Field Remedy: 2469

Subject: **Glued driveshaft - Missing service instruction**

Models:	Engines:	Option:
Insignia 2008...,Astra-J 2010...	A20DT A20DTC A20DTH A20DTJ A20DTL,A13DTE A17DTJ A17DTR A20DTH	Only vehicles with front wheel drive.

I

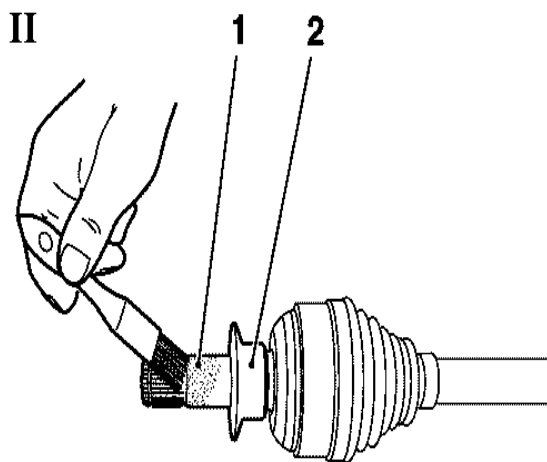
Complaint:	Drive shaft right side cannot be separated from intermediate shaft.
Cause:	Drive shaft right side is glued (Safety compound) with intermediate shaft.
Production:

Note:
New drive shaft and new intermediate shaft will be supplied as single parts and have to be glued (Pic I, arrow) together (Safety compound).

2. Adhesion of right drive shaft with intermediate shaft,

- Clean intermediate shaft and stud of drive shaft
- Mount oil slinger on inner stud of drive shaft
- Coat inner drive shaft stud with Safety compound
- Mount bearing and flange on intermediate shaft
- Plug drive shaft and intermediate shaft together.

Duration of Safety compound curing amounts at 21°C approx. 12 hours. Safety compound curing before or after the installation, when curing after installation the vehicle may not be driven, but it can be completed and be pushed.
